# Chevrolet Dealer Service Technical Bulletin

68-T-22

Subject: RESTRICTED AIR FLOW - ASTRO-VENTILATION  
SYSTEM - 1968 CAMARO SPORT COUPES

VIEW IN DIRECTION OF ARROW **A**

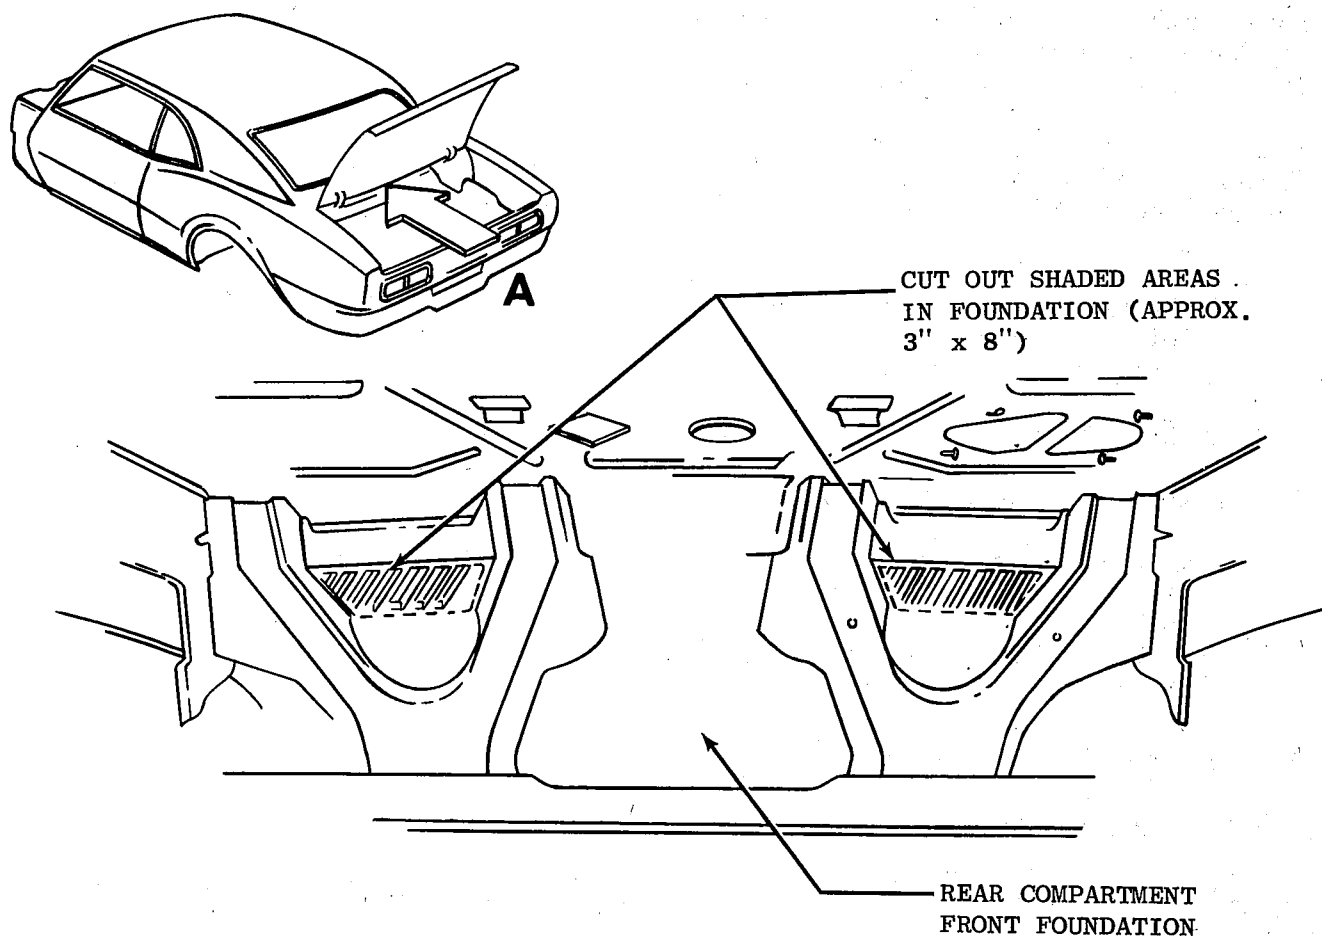
Some early built 1968 Camaro Sport Coupes with a stationary rear seat back may have inadequate Astro-ventilation air flow due to the lack of "cut outs" in the rear compartment front foundation.

When complaints of poor air circulation are encountered, check the front foundation of the rear compartment (See Sketch) to assure the "cut outs" are removed. If they are still present, perform the following operation to correct.

1. Reaching through the open rear compartment, mark the foundation (with a felt tip pen or suitable marker) to outline pattern as shown by broken line in attached illustration.

2. Remove rear seat back.
3. Remove rear compartment front foundation from the seat back support hooks (3) and lay on a suitable flat surface for cutting operation.
4. With knife (or similar tool) cut along pattern to conform with shaded areas shown in illustration.
5. Replace foundation, seat back and cushion.
